# Work Order ID 107098

Item Name: Crosstube Turning Detail

<b>DART AEROSPACE LTD</b>	<b>Work Order:</b> 107098
<b>Description:</b> Crosstube Assembly (205/212/412 Low Fwd)	<b>Part Number:</b> D212-664-147
<b>Inspection Dwg:</b> D212-664-147 <b>Rev:</b> B	<b>Page 2 of 2</b>

DRAWING NO. D212-664-147	TITLE CROSSTUBE ASS'Y (205 LOW FWD)	REV. B	<b>DART AEROSPACE LTD ENGINEERING ORDER</b>		D.E.O. NO. D212-664-147-B-1	SHEET NO. SHEET 1 OF 1	SCALE NTS
DRAWN 97	CHECKED ASS	MFG. APPR. 183	APPROVED W.P.		DE APPR. H		
DATE 11.07.15	DATE 11.07.20	DATE 11.07.21	DATE 11/07/21		DATE 11.07.21

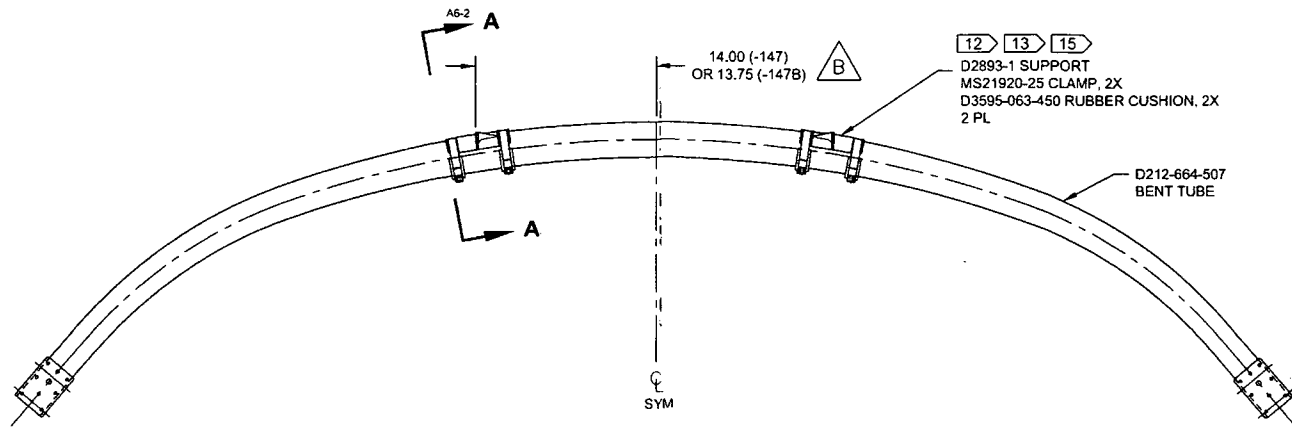
REPLACE MAGNOBOND WITH PROSEAL.

NOTE 12 & 15, SHEET 1 IS AMENDED AS FOLLOWS:

- 12) TO INSTALL D2893-1 SUPPORT: ABRAD MATING SURFACE OF SUPPORT AND CROSSTUBE WITH 180-GRIT SANDPAPER AND REMOVE RESIDUE WITH MEK (OR EQUIVALENT). APPLY A 0.04" TO 0.07" THICK LAYER OF PROSEAL 890 CLASS B-2 (OR AMS-S-8802 CLASS B-2) SEALANT TO MATING SURFACE OF SUPPORT.
- 15) TORQUE CLAMPS 80 TO 100 IN-LB. ENSURE AT LEAST 1.5 THREADS SHOWING IN SAFETY AND THAT NUT HAS NOT BOTTOMED-OUT AFTER TORQUING. **PRIOR TO PACKAGING, RE-CHECK TORQUE ON CLAMPS AFTER PROSEAL 890 SEALANT HAS CURED FOR 72 HOURS.**
